CITY OF LAKE GENEVA SPECIAL COMMON COUNCIL

1. Mayor Klein call the meeting to order
2. Pledge of Allegiance – Alderperson Yunker
3. Roll Call
4. Comments from the public as allowed by Wis. Stats. §19.84(2), limited to items on this agenda, except for public hearing items. Comments will be limited to 5 minutes
5. Discussion/Action regarding Change Order # 3 filed by Selzer-Ornst for the Library Restoration Project in an amount not to exceed \$4,700.00
6. **Adjournment**

Lake Geneva Public Library
Selzer-Ornst Construction
Owner Change Order Request

Surveillance, Security & Access Control Costs

Surveillance
Cameras

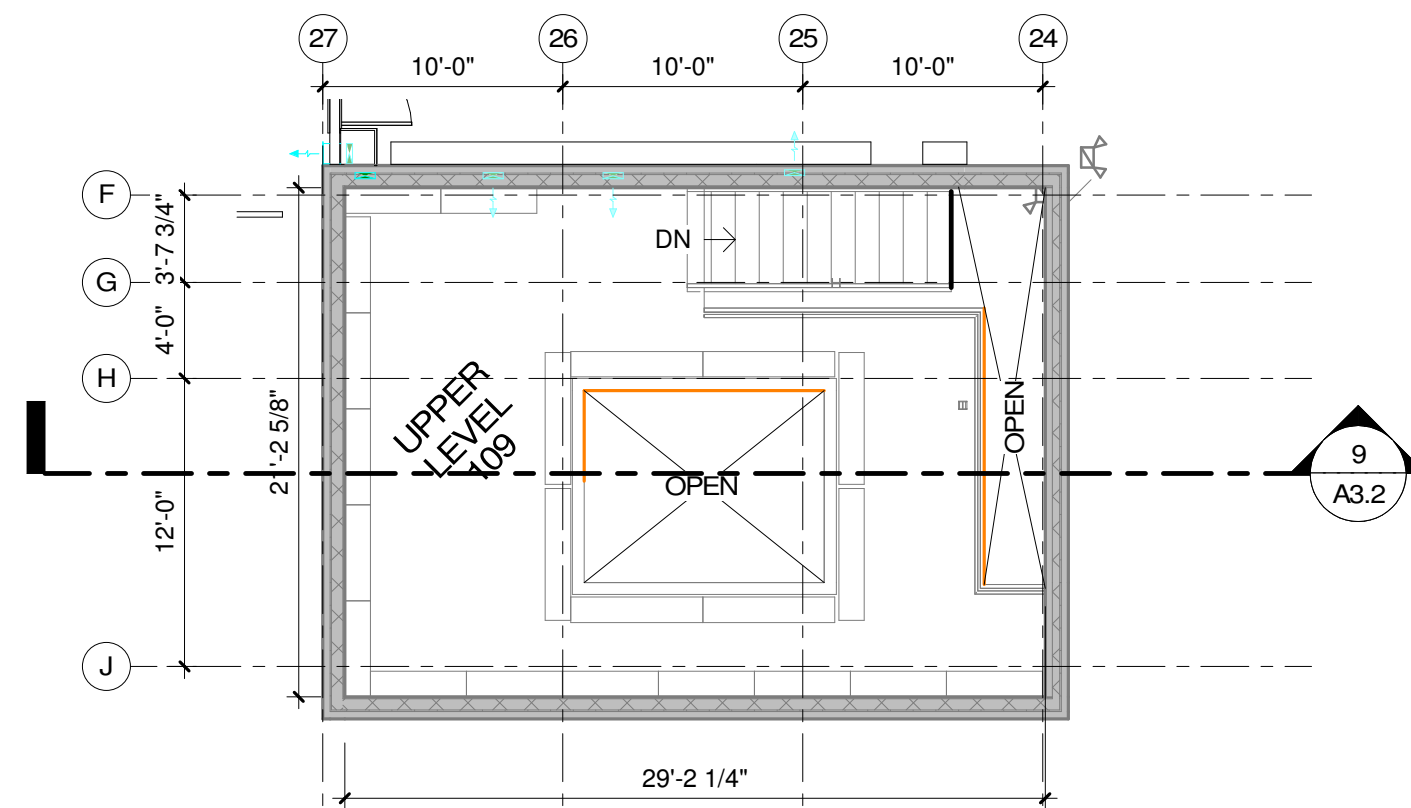
We will be pulling in 3 new cables 2 New locations and replacing 1 existing location.

We are asking that the two cameras on the west end of the building be eliminated and moved to a location on the walls behind the circulation desks and children's desk. We will supply the cameras; we only need Cat 6 cables run from the basement to j boxes on the walls approx. 12" below the ceiling. The lobby camera, book drop camera and Smith Meeting Room hallway camera should all be operational.
Please let me know if you have any questions.

1. The surveillance camera cable installation includes pulling 3 new cables to 2 new locations and 1 existing location. Cables to be owner supplied.

Access Control Locations

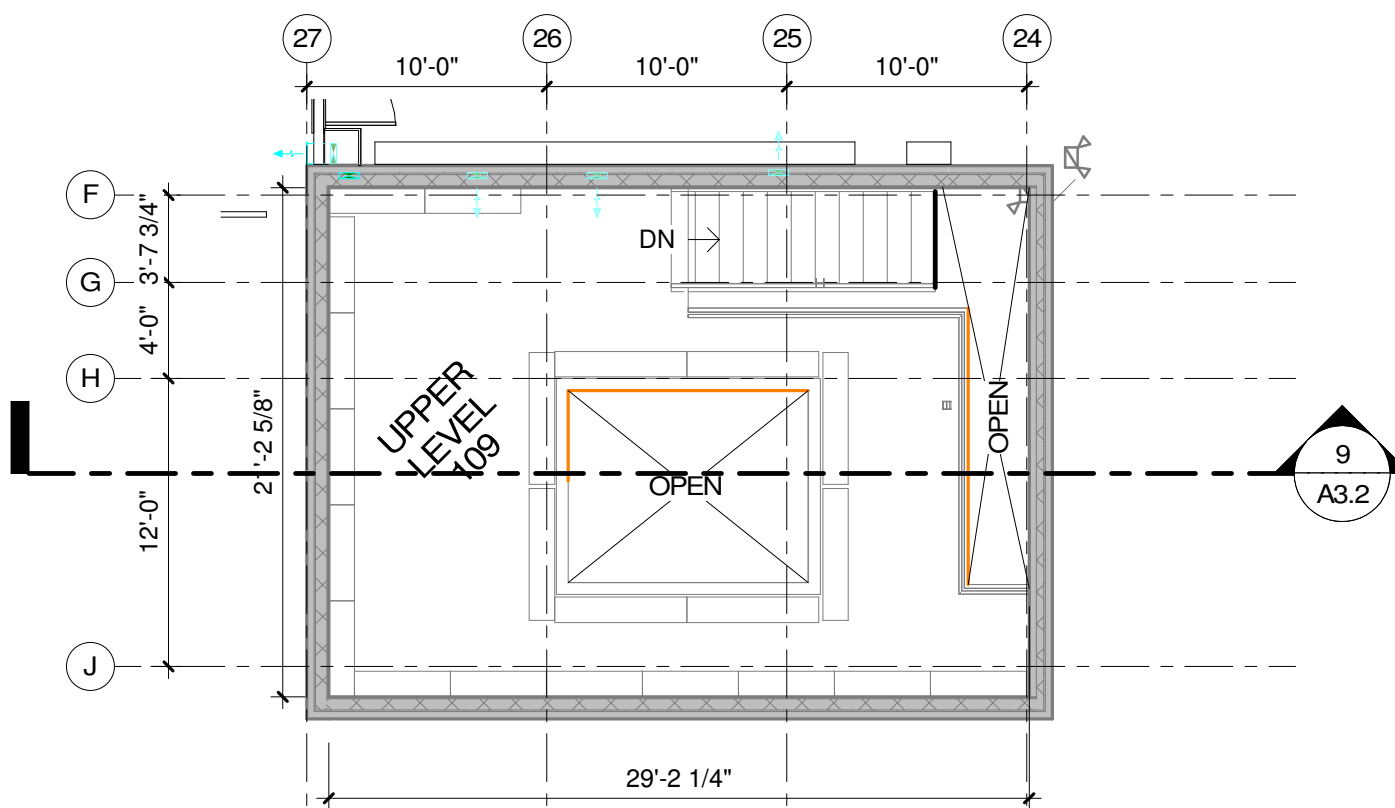
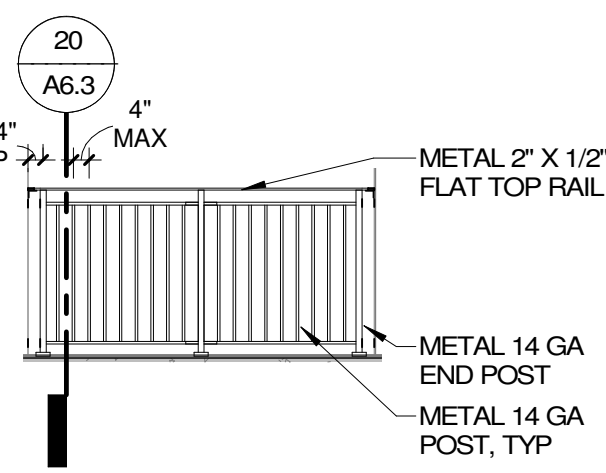
Owner Supplied cabling in 3 locations
Per Print 12-08-2021

1. Provide sleeves as needed
2. Coring
3. Provide 1 empty conduit 3/4" and J-box in ceiling as discussed
4. All caballing to be coiled up above ceiling in the 3 areas
5. As discussed

2. The electrician shall install access control wiring to 3 locations per the access control plans. Cables to be owner supplied. All cable to be coiled in 8-10' lengths above the ceiling. Subcontractor shall provide quantity one (1) 3/4" empty conduit and J-box in the ceiling per the direction of Jeff Miskie.

Existing Security Alarm

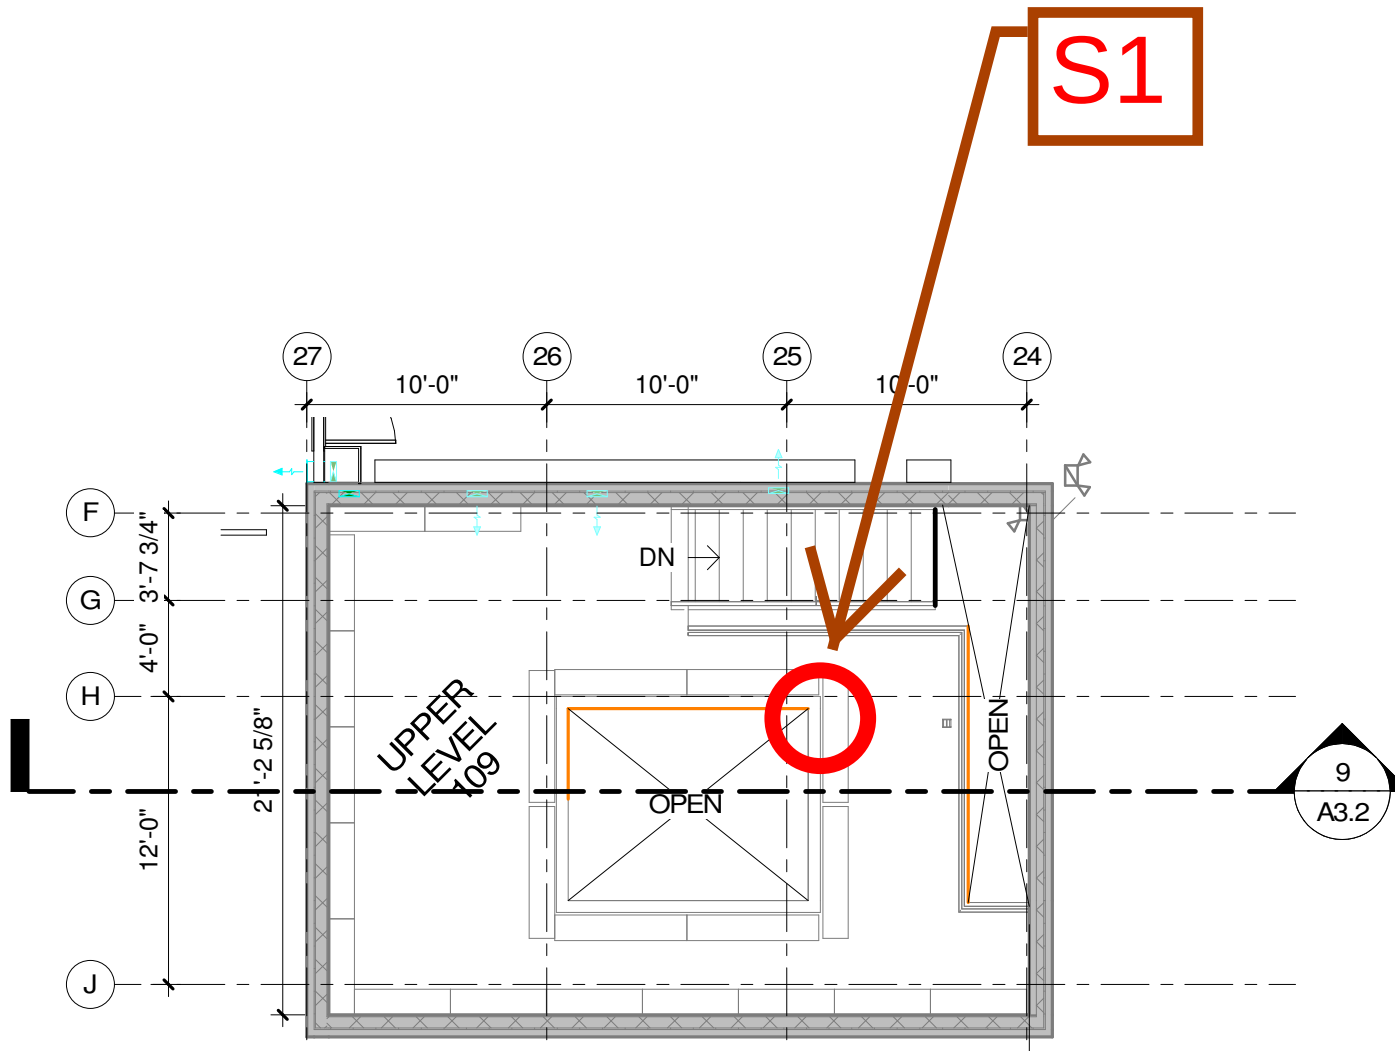
To simplify discussion, I'd like to refer to each detector by number as shown on the attached diagram. Note that this number is unrelated to the alarm zones.

During our walkthrough on Thursday, we found that the west side detectors M1, M2, S1 and S2 were all off most likely due to cables that were cut above the new men's washroom on the north end of the building.

S3 has been removed. (should we eliminate this detector or place it in director's office?)

In the staff workroom M4, the security control panel and door sensor all appear to be operational. There are power indicators and the control panel is active with the current date. The east side detectors M3, S4 and S5 were all off most likely due to cut cables above the door to the staff workroom.

With only a few exceptions the security cables were either fished or fairly well hidden. They are not hanging down except where they were cut. There is one section of exposed cable on the brick on the west end of the building that should be dressed to be more cosmetic. (Plastic Wire Mold)

2. The electrician shall install security cables per the security plan included in this change order to the following locations M1, M2, M3, S1, S2, S4 & S5.					
General note: subcontractor to test wires only. The City of Lake Geneva Public Library shall perform final testing of all equipment. Each scope references the attached plans provided by Jeff Miskie. All cabling to be installed in the ceilings in J-hooks per code and with sleeves as needed.					
Schedule Impact:	None

The below is the comments from Jeff. We will be pulling in new cables as directed. M1, M2, S1, S2, M3,S4,S5

1. All cables supplied by Owner
- 2.All terminations by Owner
- 3.All Testing by Owner
4. All cables in ceilings and basement will be free air cabling on J-Hooks per code
5. We will supply sleeves as needed
6. Plastic WireMold Brick west end off building
